Agenda Item # 9

SUB-003783-2026

Corsey-Singleton Estates at Oakleigh Subdivision

- Subdivision approval to create one (1) legal lot of record from one (1) metes-and-bounds parcel.

DETAIL SITE PLAN

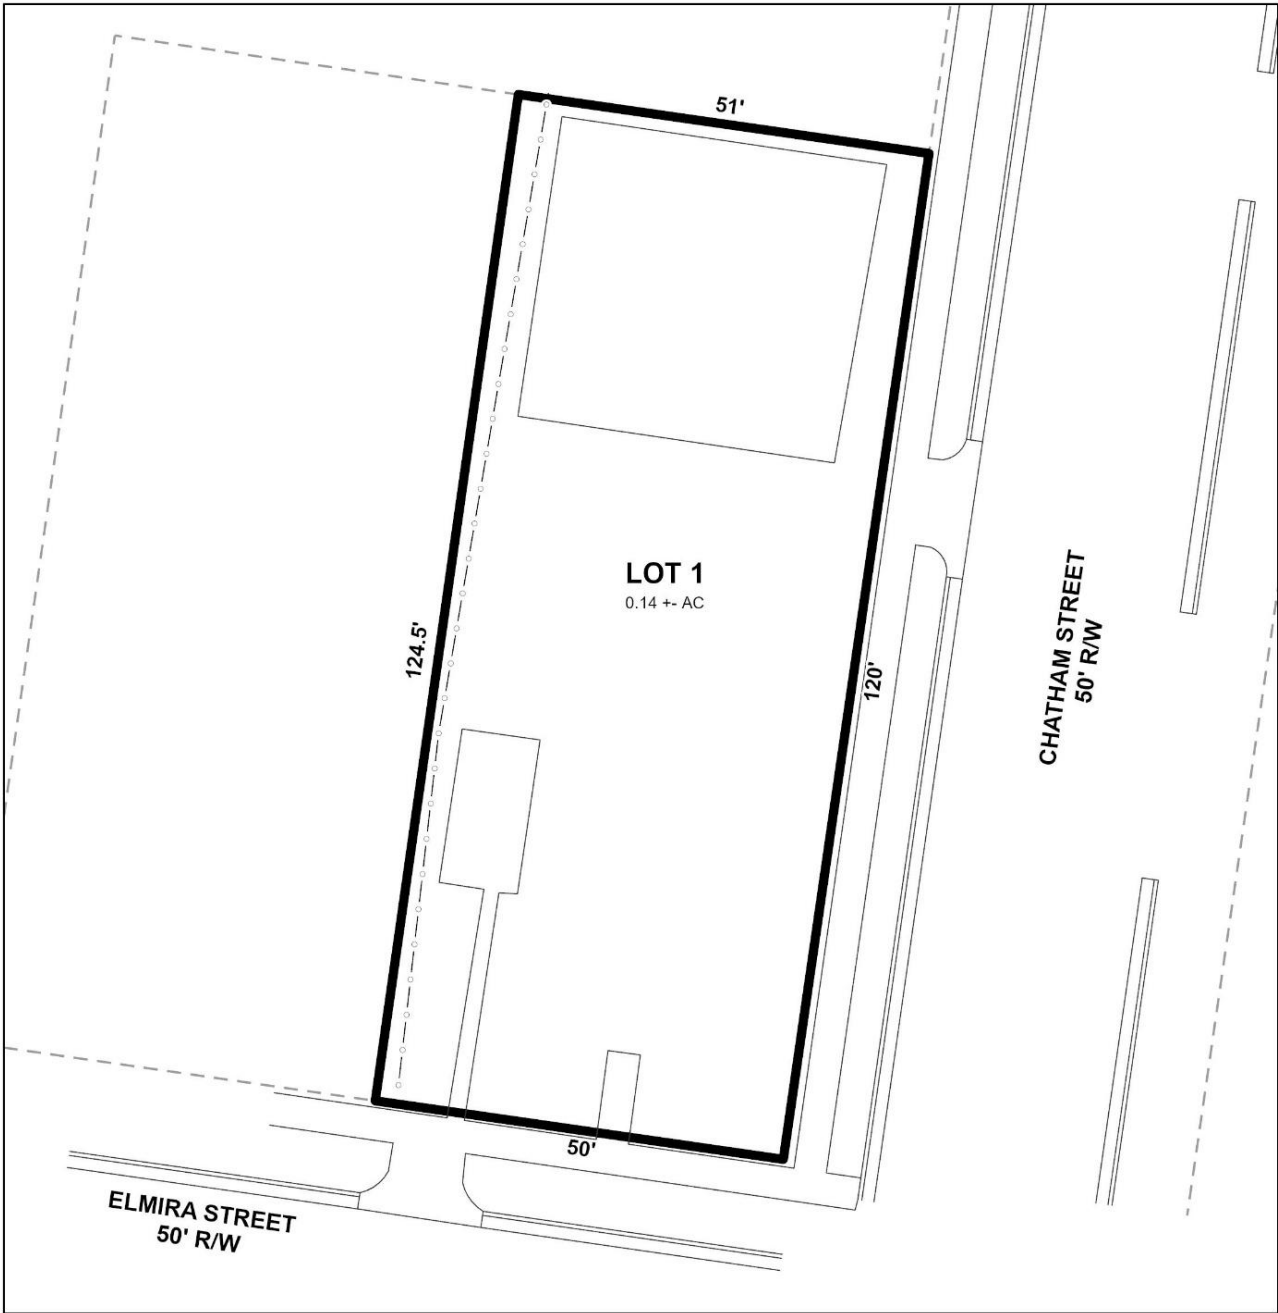
- B. Revise NOTES #13 to read - As shown on the 1984 aerial photo LOT 1 will receive the 1,500 sf of historical credit of existing (1984) impervious area towards stormwater detention requirement per Mobile City Code, Chapter 17, Storm Water Management and Flood Control) and the 4,000 SF credit provided to the original SF residential lot as follows: LOT 1 – 5,500 sf. Stormwater detention will be required for any additional impervious area that exceeds the allowable credit for that LOT.

- C. Retain NOTES 6 – 8, 13, and 15.
- D. Email a pdf copy of the FINAL SUBDIVISION PLAT and LETTER OF DECISION to the Permitting Engineering Dept. for review at land.disturbance@cityofmobile.gov prior to obtaining any signatures. No signatures are required on the drawing.

The subject site has frontage along Elmira Street and Chatham Street, both minor streets with curb and gutter improvements, each requiring a 50-foot-wide right-of-way. The preliminary plat depicts sufficient right-of-way along both streets, making additional dedication unnecessary. This information should be retained on the Final Plat, if approved.

As proposed, Lot 1 is a corner lot requiring a 25-foot corner radius. As such, if approved, the Final Plat should be revised to illustrate dedication sufficient to provide a 25-foot corner radius where Elmira Street and Chatham Street intersect, unless a waiver of Section 6.C.6. of the Subdivision Regulations is recommended by the City Engineer and Traffic Engineer.

The lot size is provided in square feet and acres on the preliminary plat and exceeds the minimum required 6,000 square feet in an R-1 Urban District. If approved, the lot size should be retained in square feet and acres on the Final Plat, adjusted for any required dedication.

The proposed lot is 50.65 feet wide and exceeds the minimum required 50-foot width for residential lots in the Urban sub-district.

The site is located in the Oakleigh Garden Historic District Overlay (HDO), where front yard setbacks are required to be consistent with those structures located on the same side of the street within 150 feet of the proposed building site, measured in both directions and exclusive of right-of-way. Because front yard setbacks within the HDO are determined by the surrounding development, a note should be placed on the Final Plat stating that development of the site shall comply with the provisions of Article 14 of the Unified Development Code, including the front yard dimensional standard applicable within the Historic District overlay.

1. Retention of the 50-foot-wide rights-of-way along Chatham Street and Elmire Street on the Final Plat;
2. Revision of the Final Plat to depict dedication of a 25-foot corner radius at the intersection of Elmira Street and Chatham Street unless a waiver of 6.C.6. is recommended by the City Engineer and Traffic Engineer;

3. Retention of the lot's size in square feet and acres on the Final Plat;
4. Revision of the Final Plat to add a note stating that development of the site shall comply with the provisions of Article 14 of the Unified Development Code, including the front yard dimensional standard applicable within the Historic District Overlay;
